# SERVICE BULLETIN

BT14-003

## ALTIMA SEDAN; HISS AND / OR WHINE TYPE NOISE FROM LOWER INSTRUMENT PANEL AREA

**APPLIED VEHICLE:** 2013-2014 Altima Sedan (L33)

Figure 1: Ground wire.

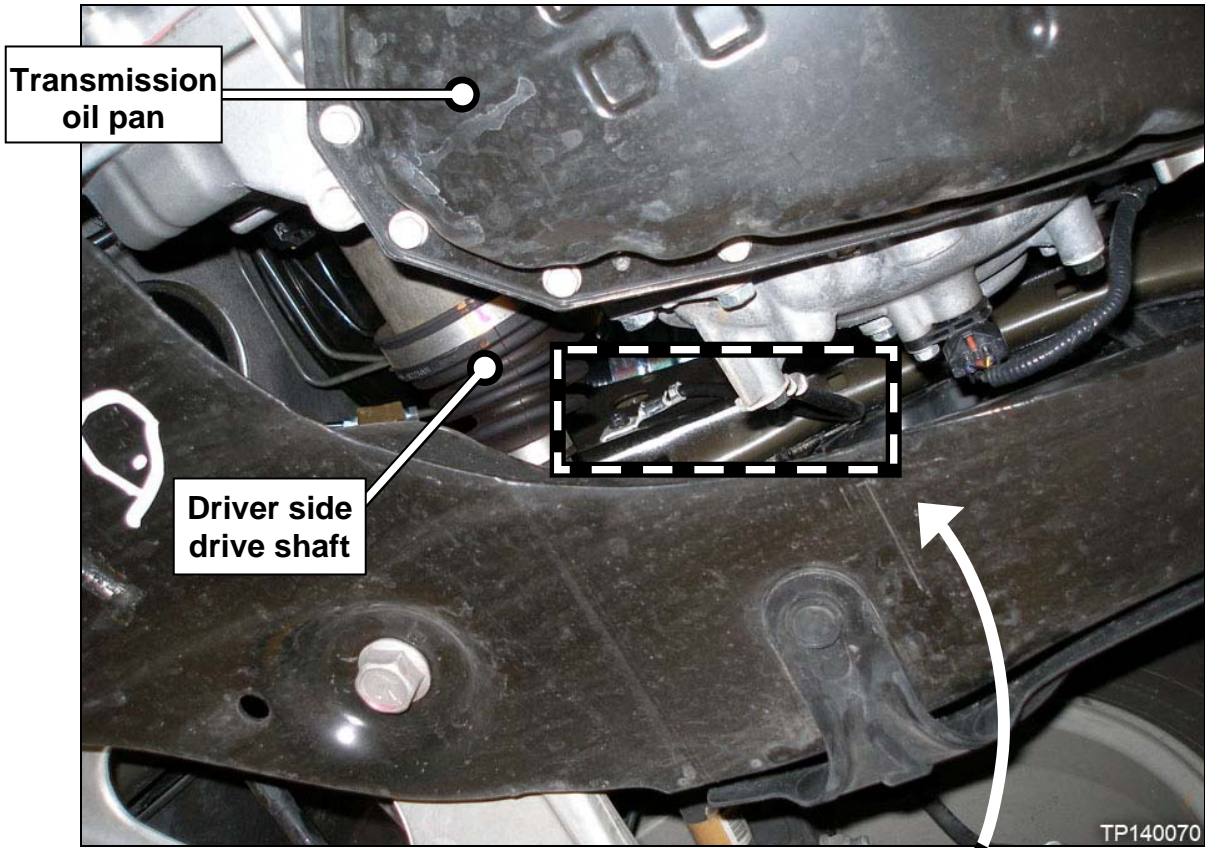
1. Remove the ground wire connected between the transmission and driver side frame rail.
2. If the noise stops after removing the ground wire in Step 1 above and repeating the procedure under **IF YOU CONFIRM**, replace the ground wire with the one listed in **PARTS INFORMATION**.
  - See page 2, Figure 1 for ground wire location.
  - Before installing, flatten the tabs on both eyelets of the new ground wire (see page 2, Figure 3).
  - Bolts torque: 10 N•m (1.02 kg-m, **88.5 in lbs**)
  - Make sure the ground wire does not twist at either end when securing the bolts.
3. If the noise does not stop after removing the ground wire in step 1 in the **ACTION** section and repeating the procedure under **IF YOU CONFIRM**, this bulletin does not apply. Go back to ASIST and the Electronic Service Manual (ESM) for further diagnostic assistance.
